Re: Harold D. Thompson Regional Water Reclamation Facility (HDTRWRF)
Lower Fountain Metropolitan Sewage Disposal District (LFMSDD)

Submittal No.:	03200-001
Date of Submittal:	November 8, 2010
Title:	Digester and Aeration Basin Drilled Pier Reinforcing, Submittal Drawing R1
Specification Section:	03200
Supplier:	Dalco Industries, Inc.

The referenced submittal has been stamped **"Make Corrections Noted"**. No additional information or resubmittal is required on these items. Please ensure that all comments below are satisfactorily addressed prior to fabrication and/or delivery of the reinforcing. Our comments are as follows:

1 AERATION BASINS AND AEROBIC DIGESTER BASINS DRILLED PIER PLAN
 SCALE: 1" = 10'

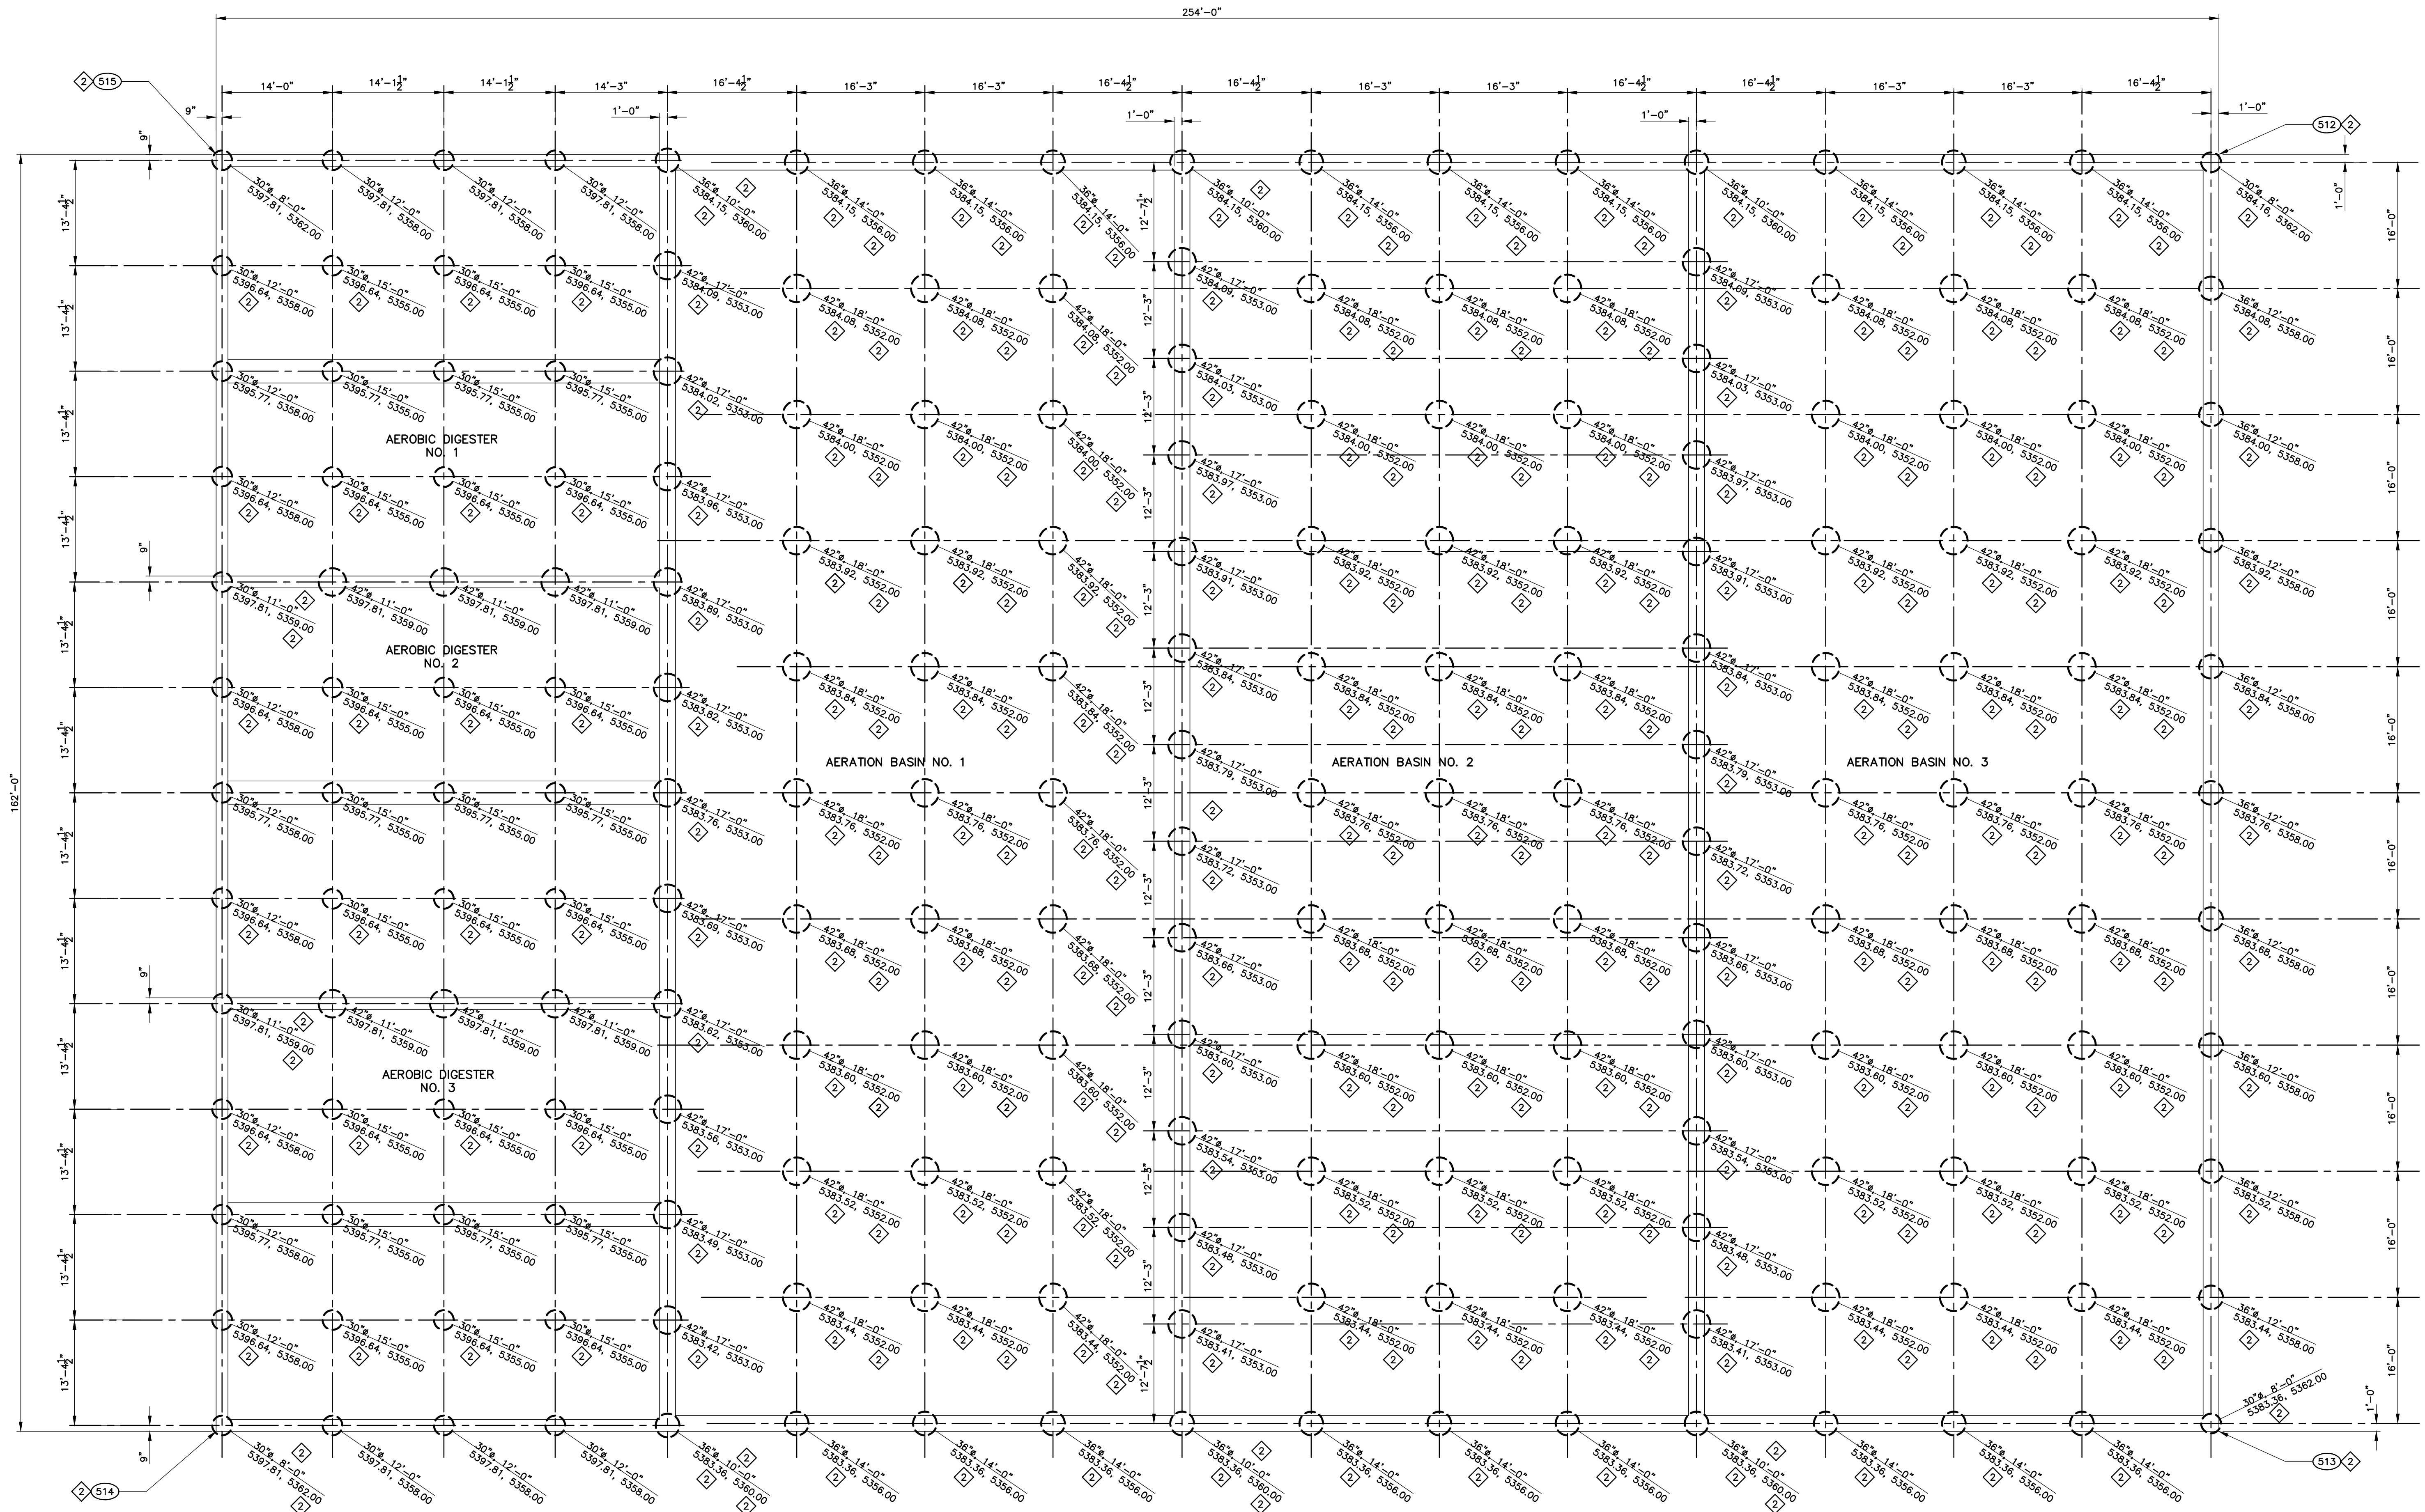
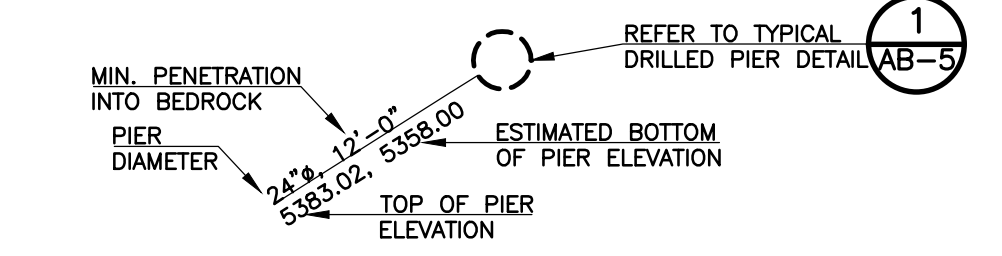
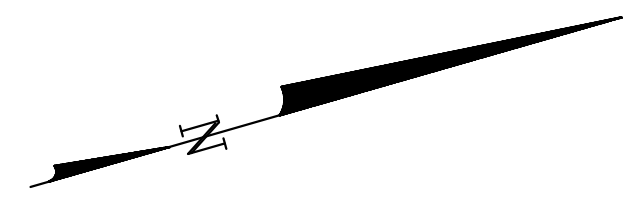
1. The length of the drilled piers listed below are 6'-0" too short as submitted. Please revise the pier length accordingly.
 - a. DP-66
 - b. DP-77
 - c. DP-88
 - d. DP-114
 - e. DP-125
 - f. DP-136
 - g. DP-161
 - h. DP-172
 - i. DP-184

2. The length of the drilled piers listed below are 4'-0" too short as submitted. Please revise the pier length accordingly.
 - a. DP-67 through DP-75
 - b. DP-78 through DP-86
 - c. DP-89 through DP-97
 - d. DP-115 through DP-123
 - e. DP-126 through DP-134

- f. DP-137 through DP-145
 - g. DP-162 through DP-170
 - h. DP-173 through DP-182
 - i. DP-185 through DP-193
3. Please provide over-length stock sizes of the vertical reinforcing bars to be cut in the field once the piers are drilled to their final dimensions, as indicated in the notes of Detail 1 on Sheet AB-5.
4. For your convenience, we have attached the Aeration Basins and Aerobic Digester Basins Drilled Pier Plan, Sheet AB-1. Please use this drawing to verify the revised drilled pier lengths given above, as well as accounting for the over-length stock size requirement for the drilled pier reinforcing mentioned above.
